# **Downtown and Burlington GO Major Transit Station Area Flood Hazard and Scoped SWM Assessment**

## **Phase 2 Terms of Reference and Scope of Work – Aug 06, 2021**

Conservation Halton (CH) staff has reviewed the Assessment of Roseland Creek Spill Memo, prepared by Wood Environment and Infrastructure Solutions, dated November 1, 2021, and the hydraulic modelling submitted the same day. We provide the following Key Comments below followed by Detailed Comments in Appendix A.

Conservation Halton (CH) staff has reviewed the draft Flood Hazard Assessment, prepared by Wood Environment and Infrastructure Solutions, dated January 10, 2022, and the hydraulic modelling submitted the same day. We provide the following Key Comments followed by Detailed Comments in Appendix A.

Figure 1: 1. A) Current Submission's Topography

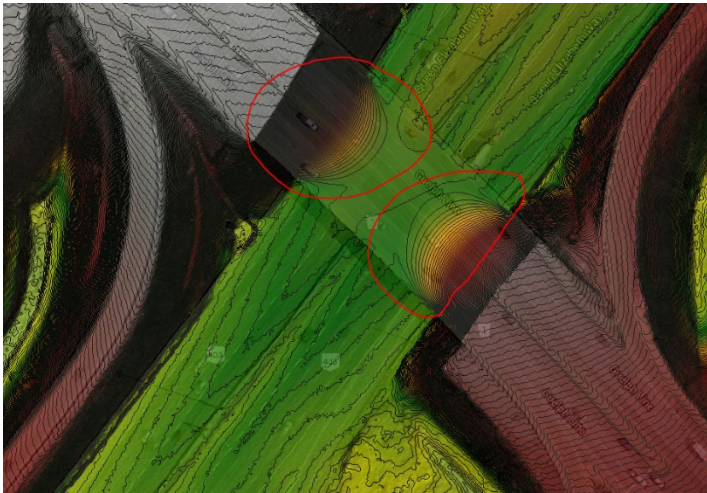
Terrain data does not accurately represent topography of the QEW below the Guelph Line overpass. Terrain data modifications are recommended in this area to ensure accuracy of the model's geometry and to improve confidence in results (refer to Figures 1 and 2 in Appendix B).

Terrain data may not accurately represent topography of the CNR underpass below the QEW/NSR overpass. Terrain data modifications are recommended in this area to ensure accuracy of the model geometry and to improve confidence in results (refer to Figures 2 and 3 in Appendix B).

Figure 5: Comparison of 'Barrier 2' Current lateral structure coding versus suggested

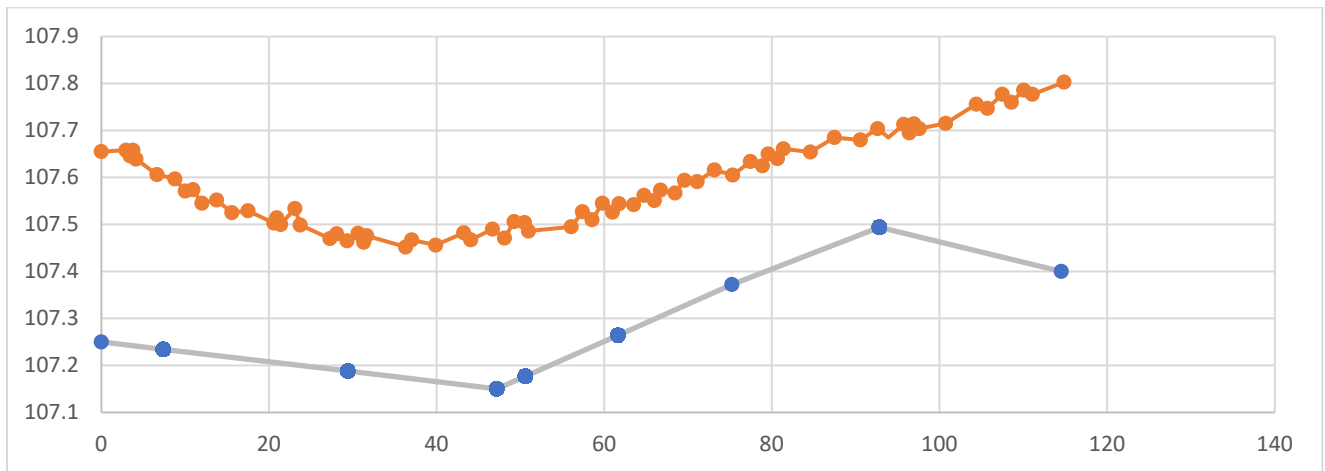
Staff apologize for the delay in identifying this recommendation, however, moving forward CH recommends that barriers be incorporated directly into the underlying DEM/Terrain instead of coding these as lateral structures. This change is intended to support improved model accuracy as well as to simplify model review.

*Figure 7: Peak Flow Comparison*

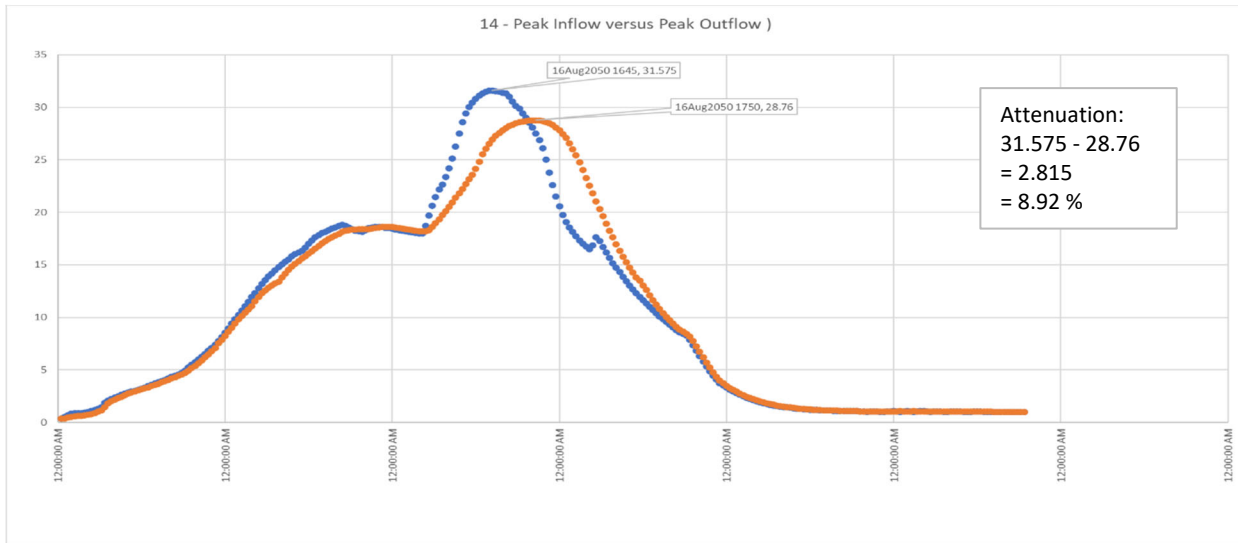
Staff acknowledge that elimination of the potential attenuative effects created by each hydraulic structure within the 2D model may not be feasible given the project's constraints (i.e., budget, timelines, etc.) and further, we acknowledge that many of the structures' attenuative effects may be insignificant. We would consider a modeling approach that only addresses structures determined to provide appreciable attenuation, however, we require a clearer understanding of attenuation caused by each structure. Significance could be evaluated based upon several factors such as: level of attenuation, risks to downstream, feasibility of an upgrade, etc. An internal analysis of attenuation at Hydraulic Structure 14 is included as an example in Appendix B; refer to Figures 7 and 8.
